Experiments with simulated jitter

Charles Moore Avago Technologies
2014 January 14

Deterministic distributions

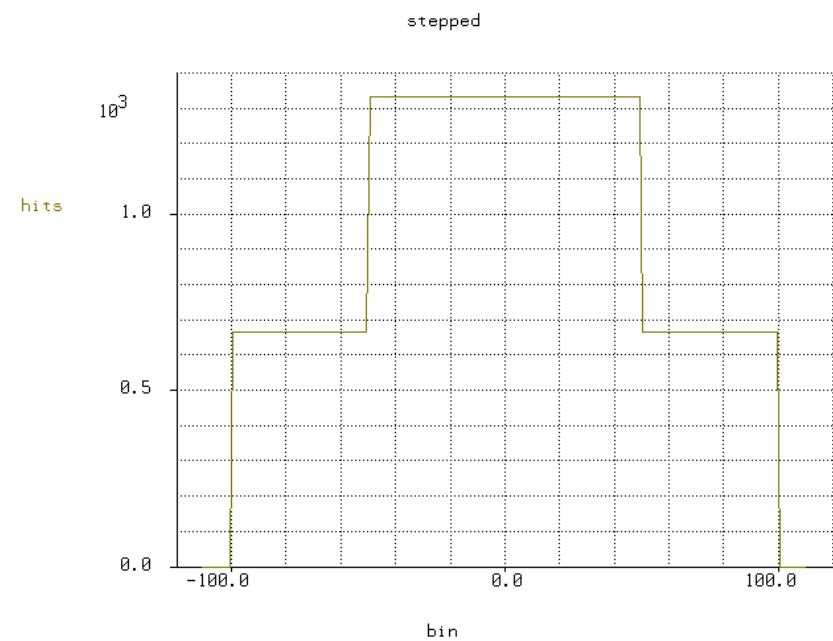
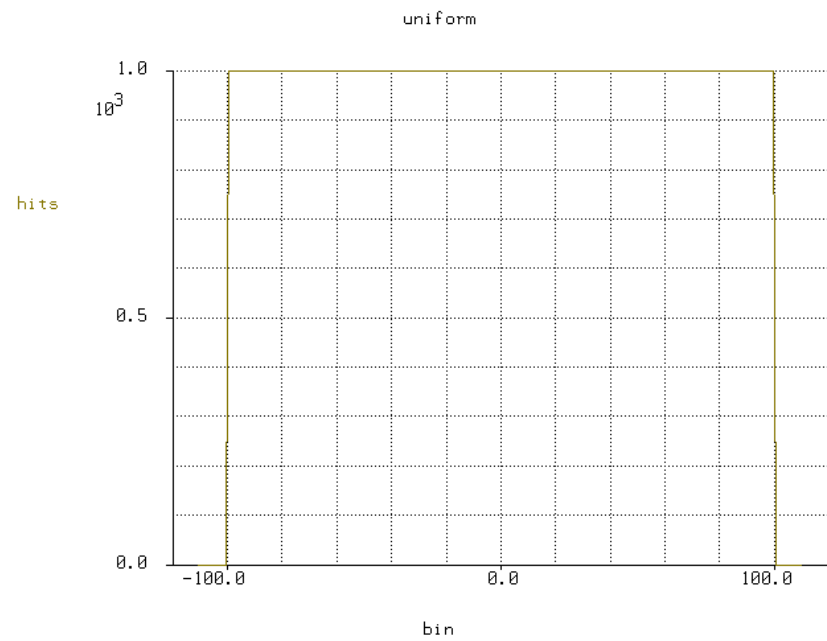
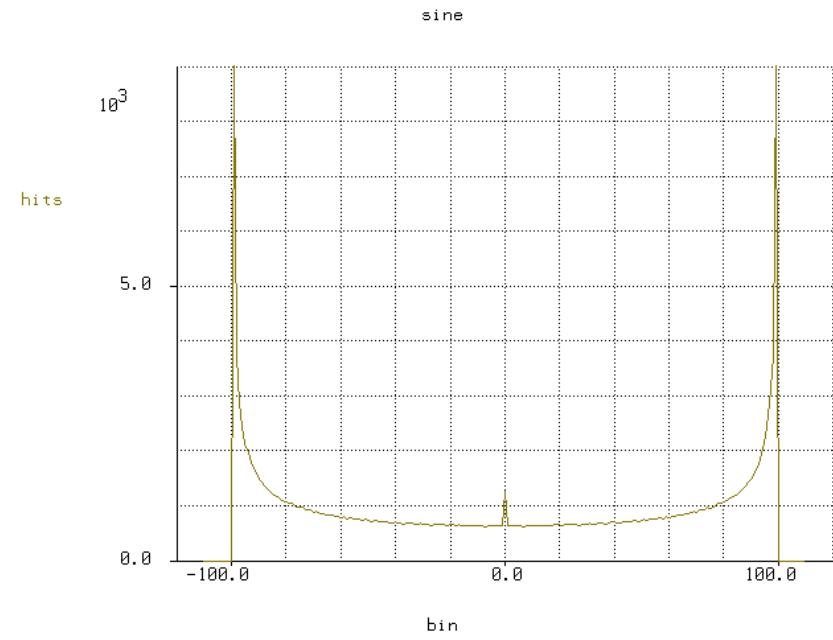
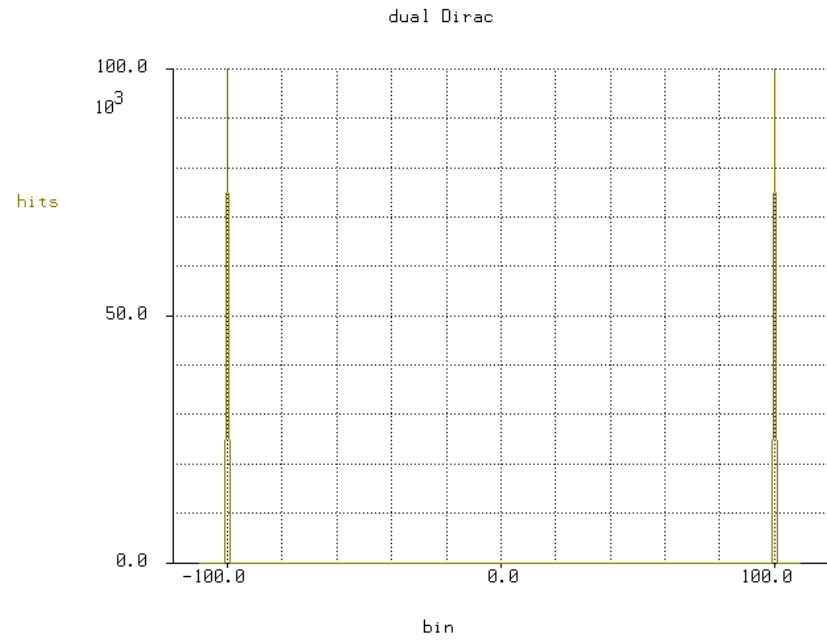
I generated simulated jitter by convolving a Gaussian random pattern with a deterministic pattern. The Gaussian random pattern was generated by convolving bits from a PRBS57 pattern enough times to get the desired variance. I used a bin size of 0.5 mUI (19.39ps). For the experiments I am reporting I use a random pattern of 10mUI RMS and deterministic pattern peak to peak of 100 mUI.

I used the deterministic patterns shown on the next slide.

Note these show the distribution for 2.0×10^5 total hits. I did most of my computation at 2.0×10^7 total hits for better resolution.

TJ spec

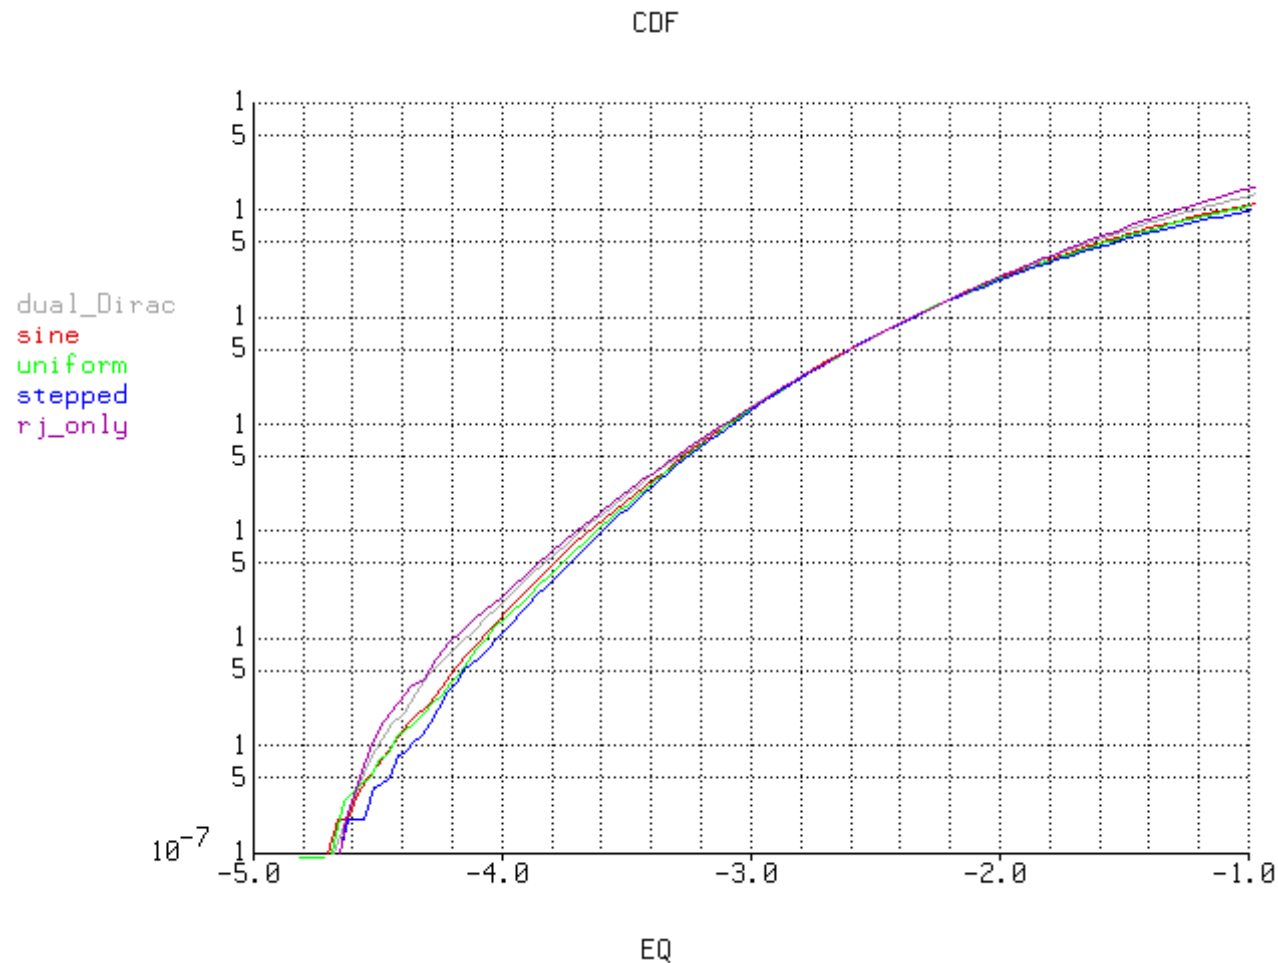
The most reasonable way to specify TJ is:
 $TJ = EBUJ + 2 \times EQ \times ERJ$

We the need to specify EQ. The value of EQ depends on the target BER for TJ. Here I plot log(CDF) vs EQ for a simulation of 2×10^6 samples.
